PLANNING COMMISSION  
DATE: 08/12/19  
AGENDA ITEM: 4B – BUSINESS ITEM  
CASE #

ITEM: **Minor Subdivision – Outlot O of Inwood Addition (Inwood 6<sup>th</sup> Addition)**

Re: Inwood 6th Addition – Kwik Trip  
Preliminary Plat Review

**ITEM:** Conditional Use Permit - Kwik Trip Convenience Store/Fuel Station

PRELIMINARY PLAT

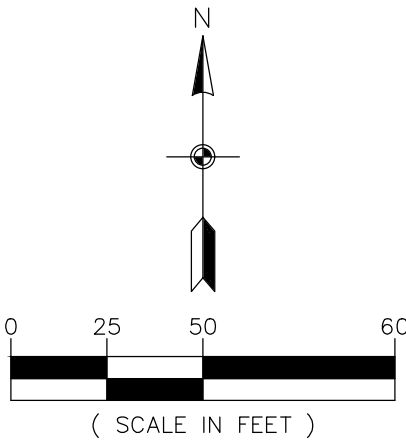
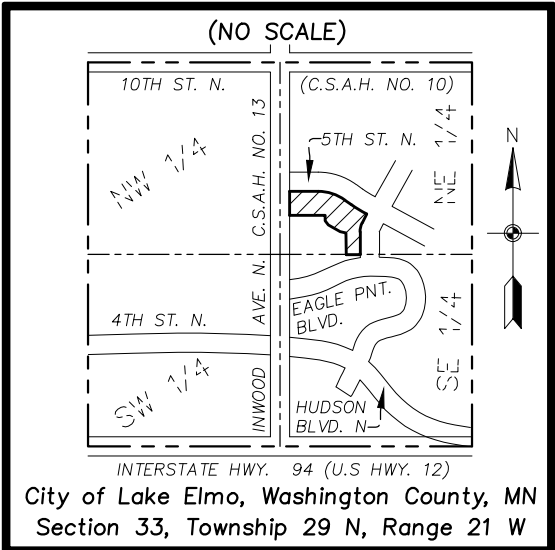
- The Preliminary plat and project plans should be revised to show the proposed lot lines and easements consistent on each set of plans.
- Drainage and utility easements must be provided for any public utilities constructed as part of this project, including City-owned watermain and hydrants, with easements shown on the plat and on the project plans. Any watermain lines serving hydrants placed internal to the site require minimum 30-foot-wide easements centered over the hydrants and pipe. These easements must be dedicated to the City and be provided in the City's standard form of easement agreement.

- The developer/owner should consider adjusting the east lot line of Outlot A further west to facilitate shared commercial driveway access between Outlot A and Outlot B. As proposed, Outlot B would not have access to the new driveway along the east side of Outlot A as there would be a strip of land as part of Outlot A along the east side of the driveway.

1. Outlot ownership should be identified on the Preliminary Plat and on the Preliminary Plans. Outlots A and B should be shown as Developer owned.
2. Lot lines and easements are not shown consistently between the Preliminary Plat and the Preliminary Plans. The plans must be revised to accurately reflect the proposed plat. The lot lines and easement locations may be subject to revision once they can be accurately reviewed with respect to the proposed improvements.

3. Drainage and utility easements must be provided for any public utilities constructed as part of the project, including City owned watermain and hydrants, with the easements shown on the preliminary plans.

4. Consideration should be given to adjusting the east lot line of Outlot A further west to facilitate a shared commercial driveway access between Outlot A and Outlot B. See comment #3 below for Site Plans, Traffic and Access Management.

1. All required modifications to the plans as requested by the City Engineer in the review letter dated August 6, 2019 shall be incorporated into the plat and project plans. The City shall approve all plans before releasing the final plat for recording.

4. The final plat shall show a 10-foot-wide drainage and utility easement along all property lines.
5. All easements as requested by the City Engineer and Public Works Department shall be documented on the Final Plat before the execution of the final plat by City Officials.
